BCA Capability Statement

Triple Two Nine Industrial Development
Early Childhood Centre
13 Endeavour Road, Caringbah

Aliro Group

13 June, 2025

C3D5

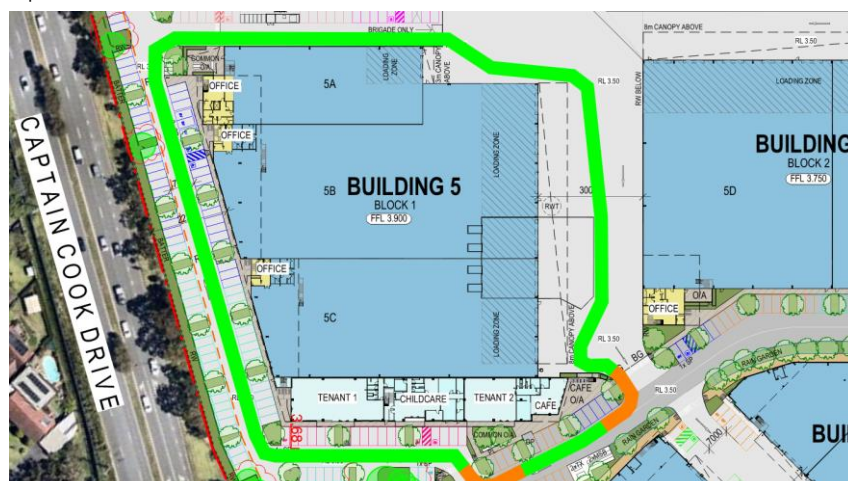
Requirements for Open Spaces and Vehicular Access: Open space and vehicular access required by C3D4 must comply with the requirements of sub-clauses (a) & (b) of this Part whereby they must be 6m wide within 18m of the external walls of the building and of a suitable bearing capacity and unobstructed height to permit the operation and passage of FRNSW vehicles.

Comment: Refer to the below mark-up identifying the paths of perimeter vehicular access, with compliant access paths shown in **green**, paths >18m from the building shown in **orange**, and areas to which there is no perimeter vehicular access shown in **red**. It is understood that a **Fire Engineering Performance Solution** is proposed to address the below pictured deviations from the BCA DtS requirements.

C3D14

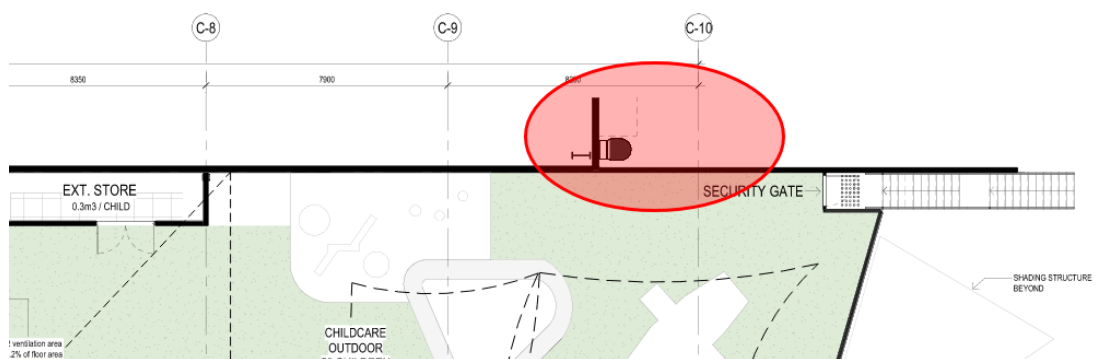
Electricity Supply System: An electricity substation, electrical conductors & main switchboards which sustain 'emergency equipment' operating in the emergency mode, located within a building must—

- + Be separated from any other part of the building by construction having an FRL of not less than 120/120/120; and
- + Having any doorway in that construction protected with a self-closing fire door having an FRL of not less than -/120/30
- + Electrical conductors which supply a substation or main switchboard sustaining emergency equipment operating in the emergency mode –
- + Have a classification in accordance with AS/NZS 3013 of not less than—
 - If located in a position that could be subject to damage by motor vehicles — WS53W; or
 - Otherwise — WS52W; or
- + Be enclosed or otherwise protected by construction having an FRL of not less than 120/120/120.

Where emergency equipment is required in a building, all switchboards in the electrical installation, which sustain the electricity supply to the emergency equipment switchgear must be separated from the non-emergency equipment switchgear by metal partitions designed to minimise the spread of fault from the non-emergency equipment switchgear.

Comment: To be noted by the Architect. Provide plans demonstrating compliance as part of the CC application package.
